**NEIGHBORS BRANCH/WALTON CRAWLEY BRANCH
STREAM & WETLAND RESTORATION SITE**

FINAL
YEAR 5 (2020) ANNUAL
MONITORING REPORT

RE: Neighbors Branch/Walton Crawley Branch Monitoring (DMS Project # 92872, Contract # D09023S)
Final Year 5 (2020) Annual Monitoring Report

Axiom Environmental, Inc. (AXE) is pleased to provide you with one hard copy and one cd of electronic files for the Final Neighbors Branch/Walton Crawley Branch Year 5 (2020) Annual Monitoring Report. We received your comments via email on January 15, 2021 and have addressed them as follows.

**FIGURE
 2B**

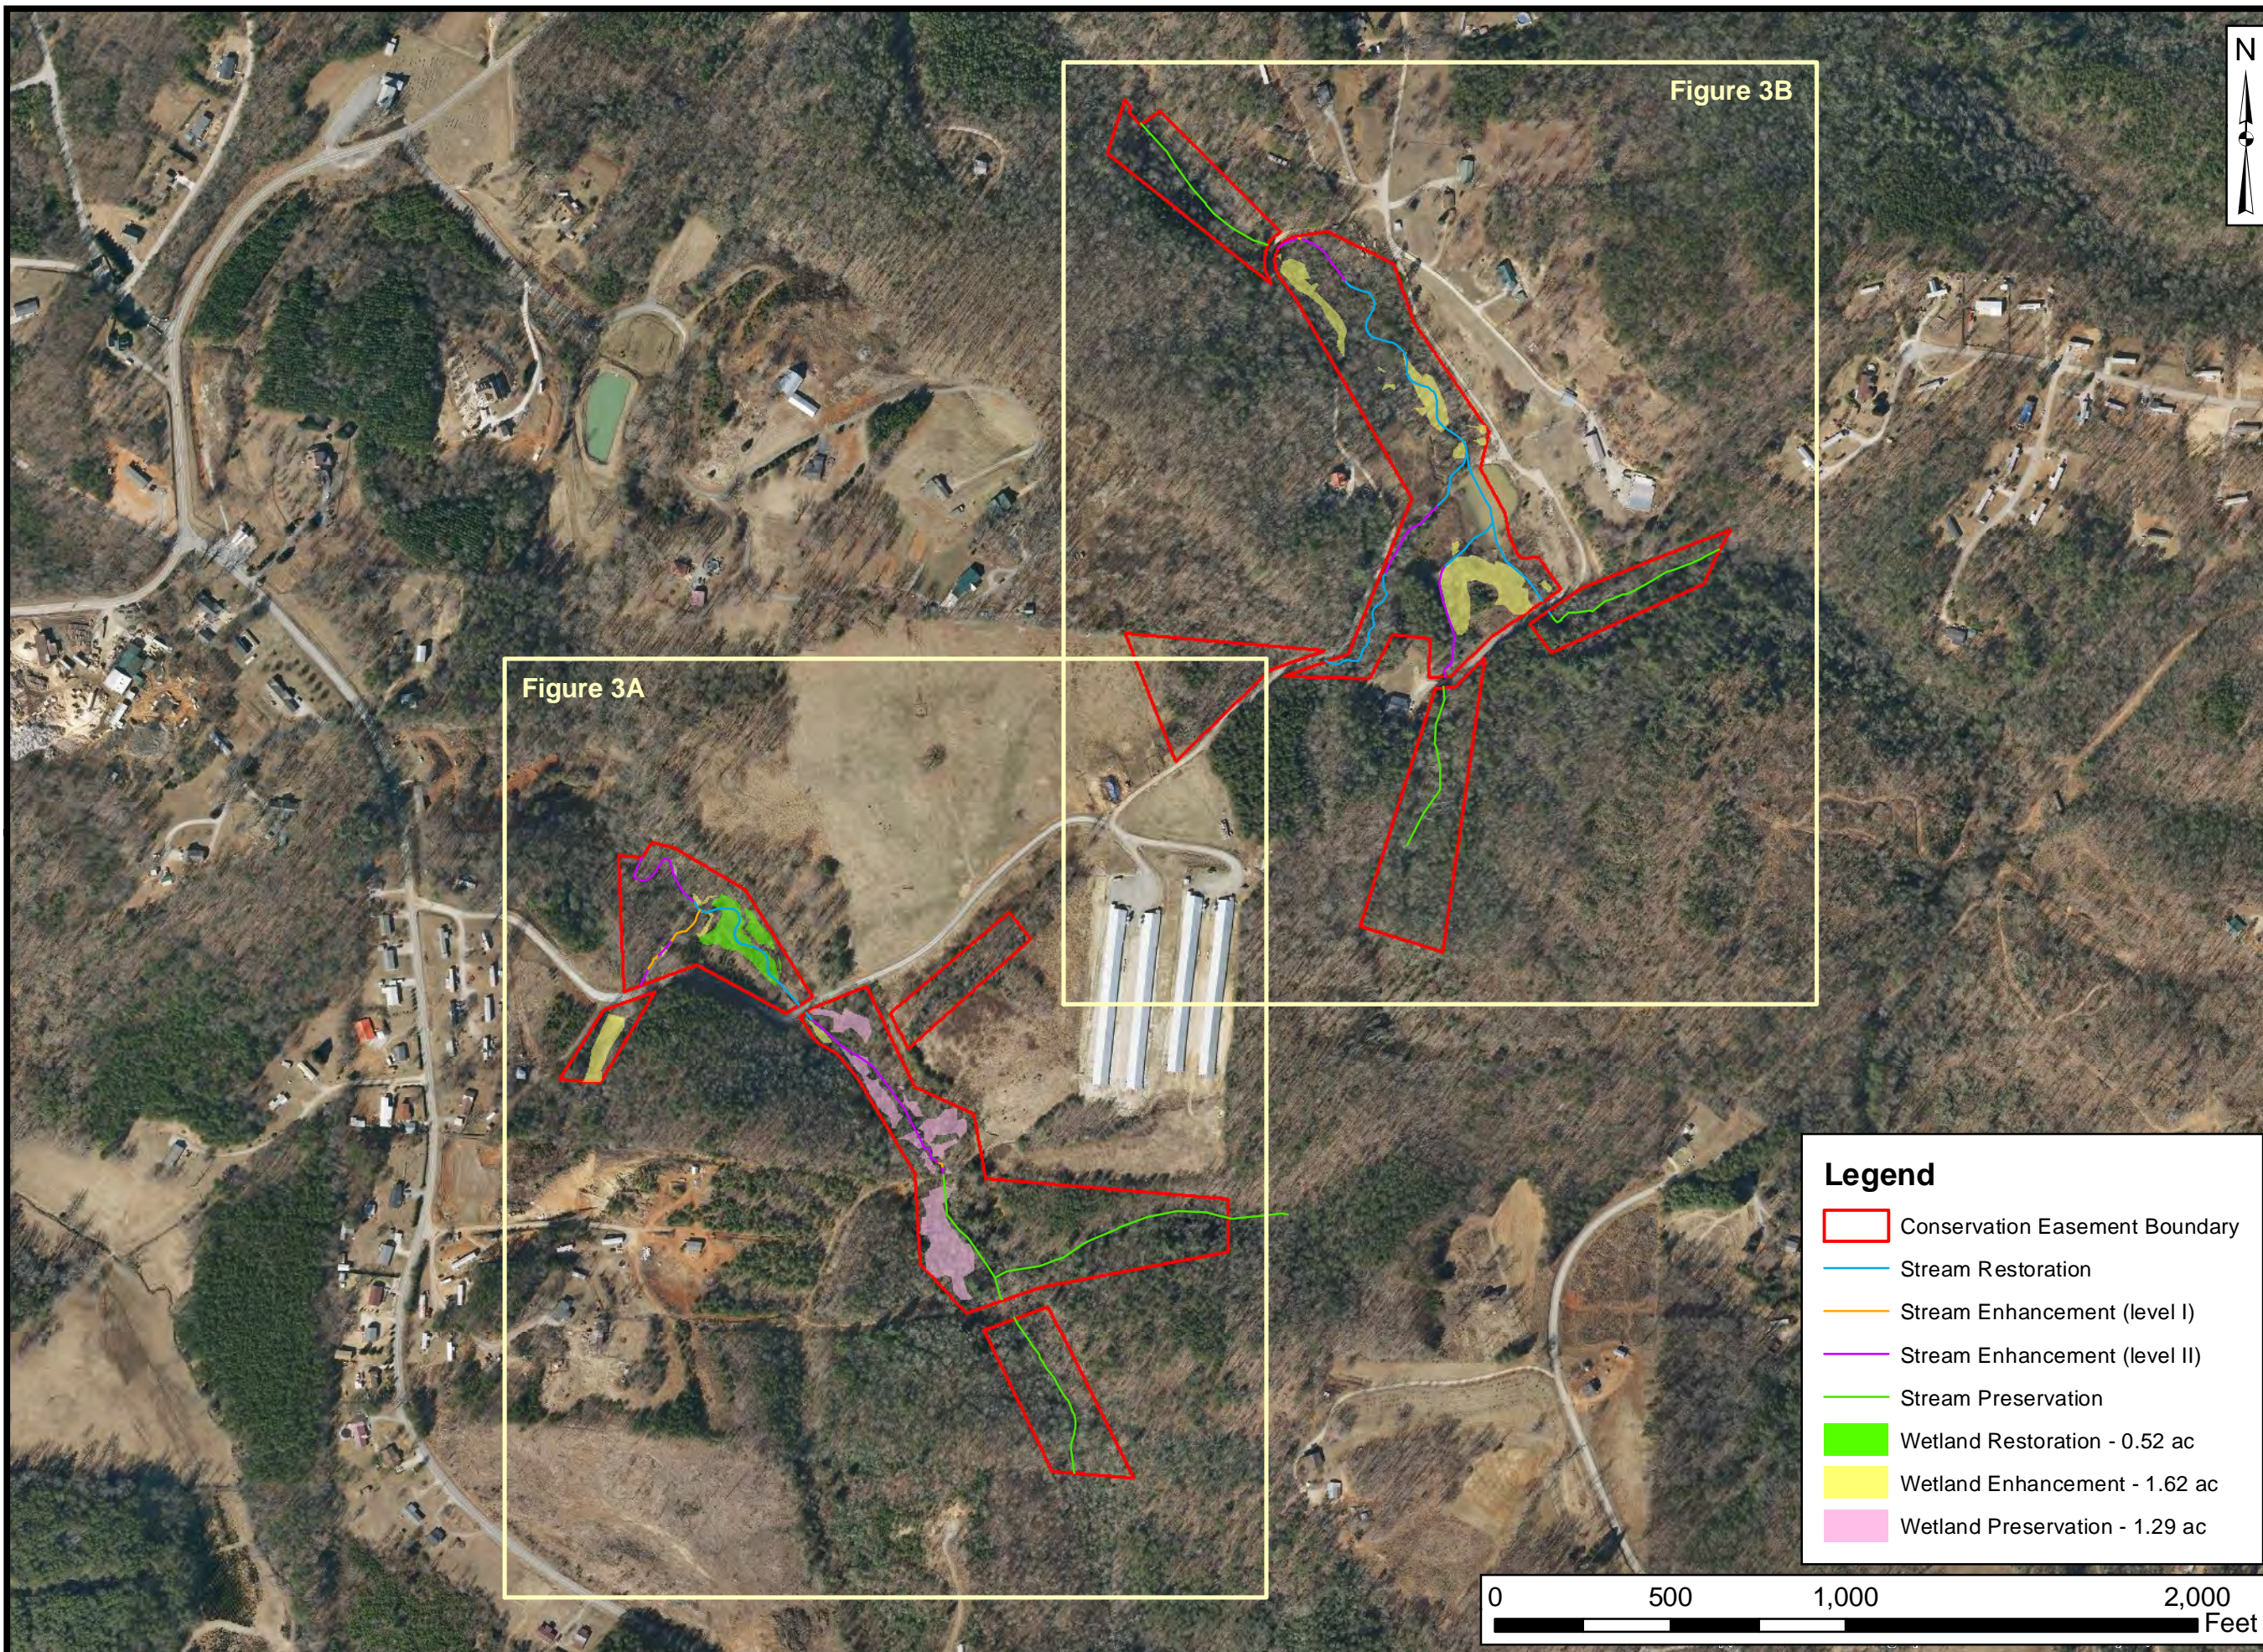
- It appears that there are 2 encroachment features in the digital submission, but only one is displayed on Fig 2B. Please include this encroachment on the CCPV and discuss briefly in report, or remove the encroachment feature from the digital submission if it is not relevant.
The irrelevant encroachment area was removed from the shapefile.

Figure E1: Neighbors Branch/Walton Crawley Branch 30-70 Percentile Graph for Rainfall

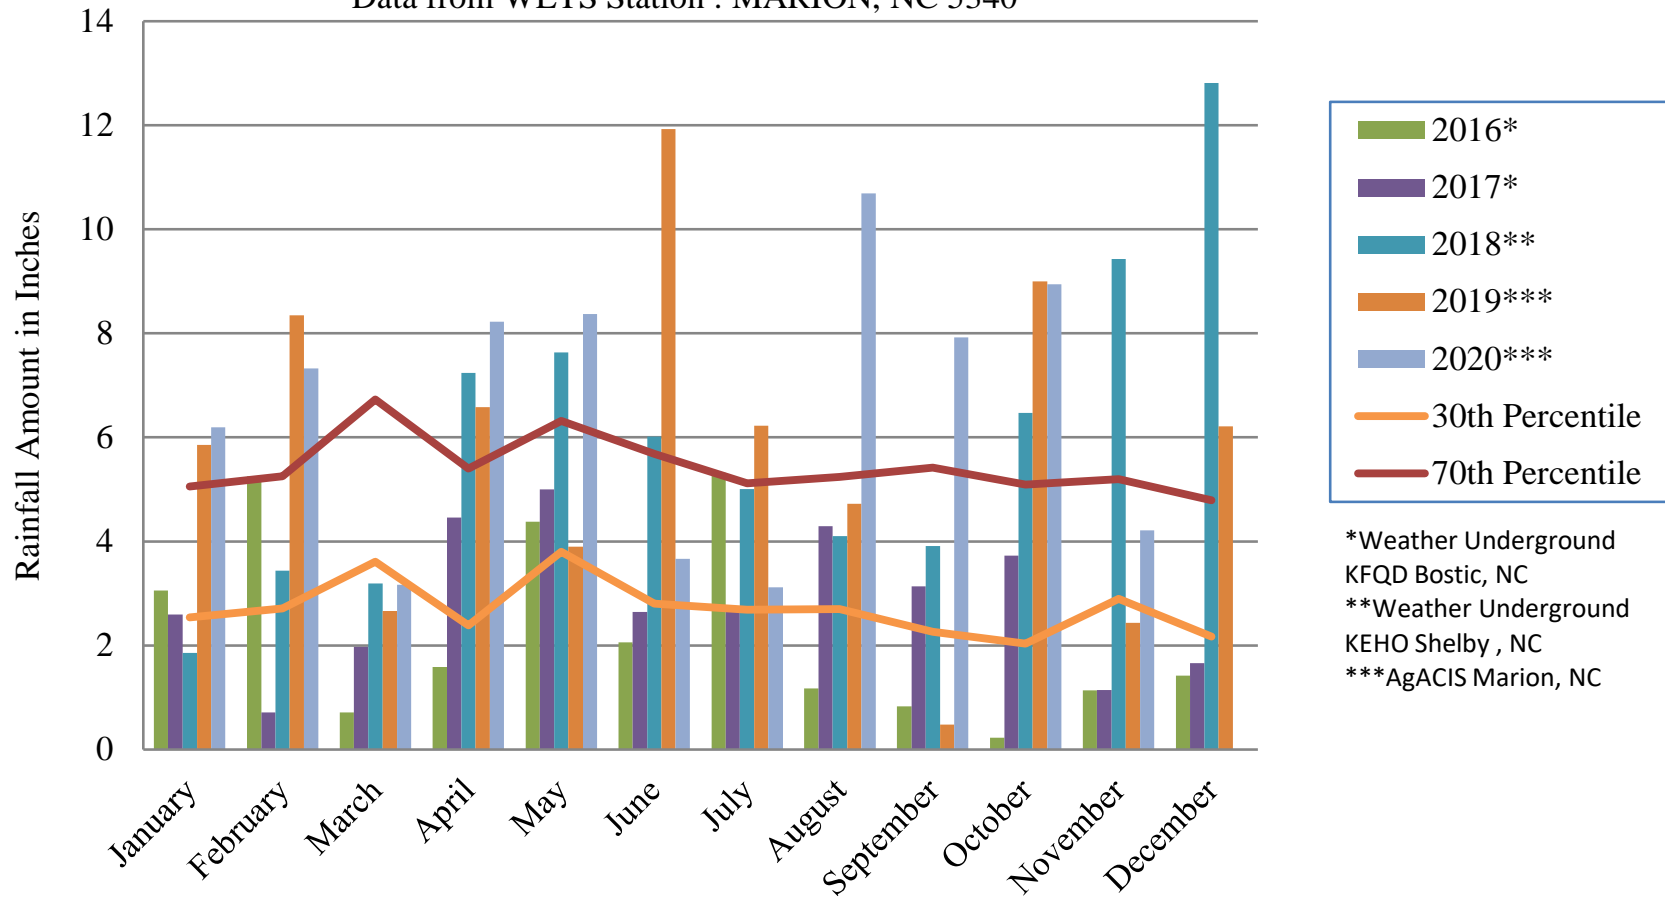
- Figure E1: The legend has * symbols next to the years. Are there notes associated with the * that should be included with the table? Please update or remove as necessary.
*The * symbols correspond with data citations that didn't print for the draft submittal. The citations have been re-added to the figure.*
